S E R V I C E N O T E

Agilent 43521A Downconverter Unit

Serial Numbers: JP1KG00101 / JP1KG00158

DATE: September 2000

Figure 1. AC Inlet Connector

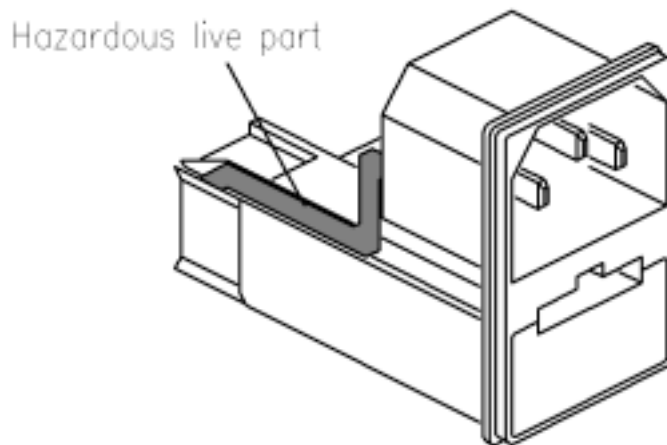
The AC inlet (P/N 1252-6951) has the potential to slip out of the instrument's rear panel slot if the AC power cord is forcefully pulled in a diagonal direction. When this happens, an exposed connection on the AC inlet module may touch the rear panel of the instrument and cause an electrical short if the AC power cord is still connected to the AC power outlet. See Figure 1.

In the worst case, there is also a possibility of an electric shock hazard to the user if the user completes a circuit between the instrument panel and another grounded connection while the AC power cord is still connected to the AC power outlet.

- Remove the AC power cable from the AC power outlet and the product.
- Remove the top, bottom, and side covers.
- Seal the hot line terminal on the AC inlet with silicon paste (P/N 5183-4112).
- Reinforce the connection between the AC inlet and the rear panel with silicon paste.
- No adjustments and performance tests are required after this modification.

- Remove the AC power cable from the AC power outlet and the product.
- Remove the top, bottom, and side covers.
- Replace the rear panel assembly with P/N 43521-00213.
- Install the new fuse P/N 2110-1017.
- No adjustments and performance tests are required after this replacement.

Figure 2. Repair Completed Label

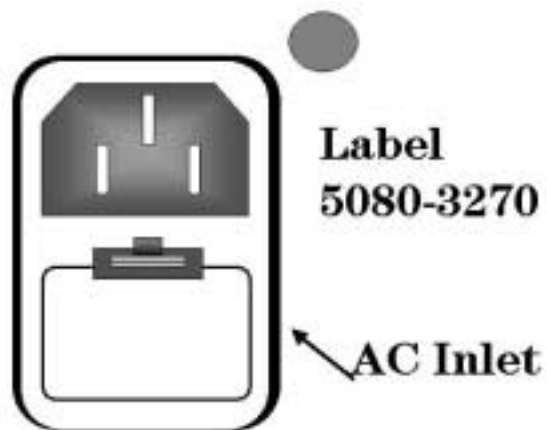
After completing the above instructions, stick the label (P/N 5080-3270) next to the AC Inlet on the rear panel as a mark that this repair has been completed. See Figure 2.
